STAFF REPORT AND DECISION

Project Name: Stonehill (SP2:06-16)

Report Date: August 17, 2017

Proposal: The applicant is seeking phased site plan approval. Phase 1 will consist of a 3,600 square foot, one-story convenience store with an 8 pump gas station with associated parking and infrastructural improvements. Phase 2 will consist of a 4,950 square foot, one-story single or multi-tenant retail building and associated infrastructural improvements. A boundary line adjustment is also proposed to adjust the property lines of the two existing parcels.

1. Proposed Site Plan

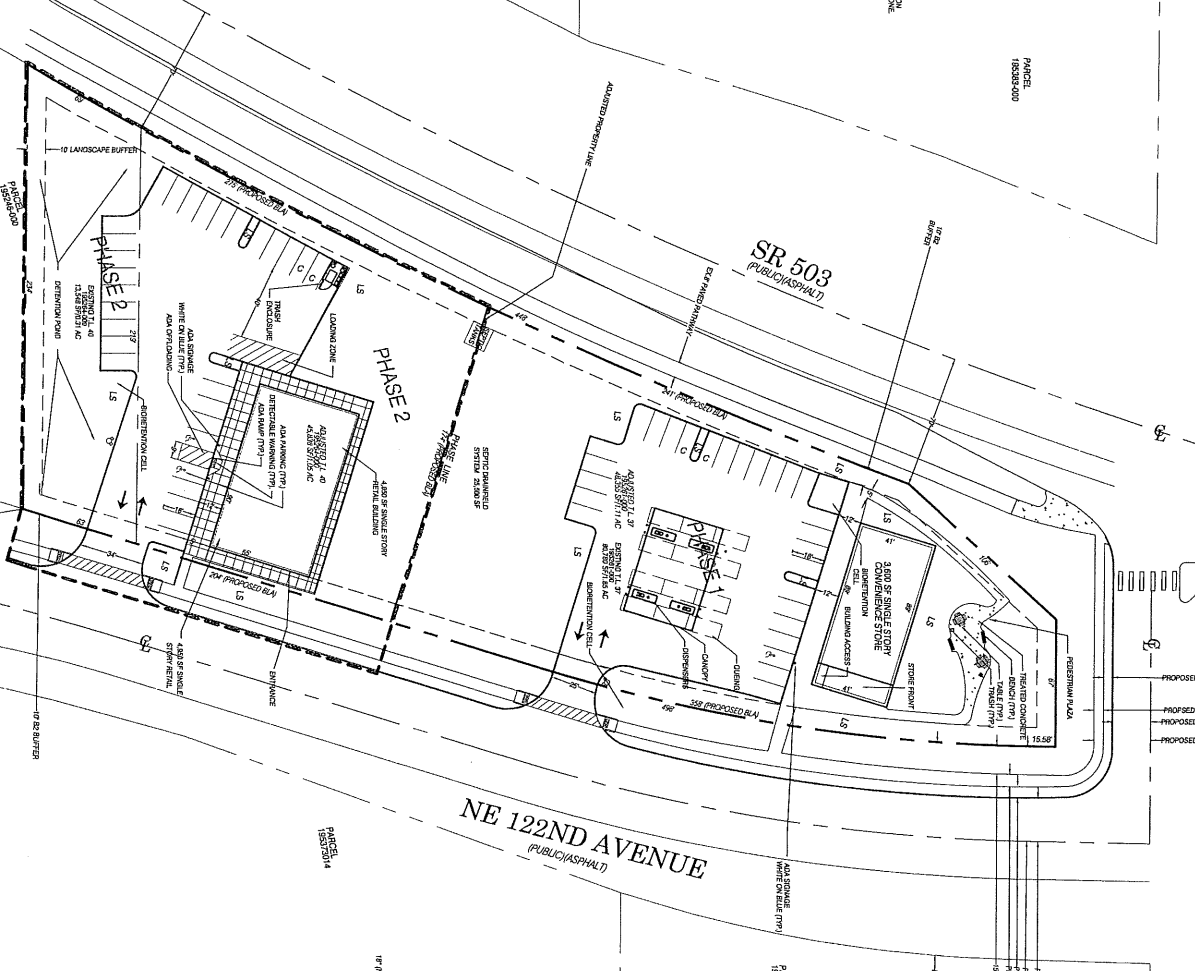
Finding: Fire access to both sites is by way of NE 122nd Avenue. **Provide location of required “No Parking – Fire Lane” signage/stripping at the southern portion of both parking lots.**

Finding: Outdoor storage is not proposed with this application. The site plan shows a trash enclosure on the northwest side of the parking lot of the retail building. The landscape plan shows a B3 buffer around the trash enclosure. **Prior to final site plan approval, provide details for the trash enclosure.**

Finding: The plans do not show any mechanical or other equipment. Any equipment must be screened from the street and any abutting residential lots with a B2 buffer. **Prior to final site plan approval, indicate on plans all proposed equipment screened with a B2 buffer.**

Finding: B3 – high screen buffers are required to provide a high degree of visual screening between potentially incompatible zones. This buffer consists of a six-foot-high fully sight-obscuring fence with a landscape strip on the interior of the fence along the perimeter of the rear yard. **Prior to final site plan approval, revise the landscape plan showing a six-foot-high sight-obscuring fence and a landscape strip with B3 plantings along the south property line.**

Screening along public streets shall be a minimum three feet in height. The landscape plan submitted indicates shrubs along parking areas 16"-21" at planting. **Prior to final site plan approval, submit a revised landscape plan that assures a mature height of 3 feet.**

Trash enclosure: There is no trash enclosure in Phase 1 on the site plan.

- p. Showing trash enclosure details.
 - q. Showing mechanical equipment screened with a B2 buffer.
 - r. The landscape plan showing a six-foot-high sight-obscuring fence and a landscape strip with B3 plantings along the south property line.

- s. The landscape plan assures the shrubs mature to three feet in height along public streets.
 - t. Clearly indicate the location of the ADA parking access aisle for the north parking lot. Show any curb ramps and detectable warnings at this location. The drawings shall provide information showing how changes in elevation will meet the accessible route requirements (spot elevations, ramp details, etc.).

- u. Provide location of required "No Parking – Fire Lane" signage/stripping at the southern portion of both parking lots.
2. Submit a pavement deflection testing report on the adequacy of the existing pavement on NE 122nd Avenue and SW 40th Street.
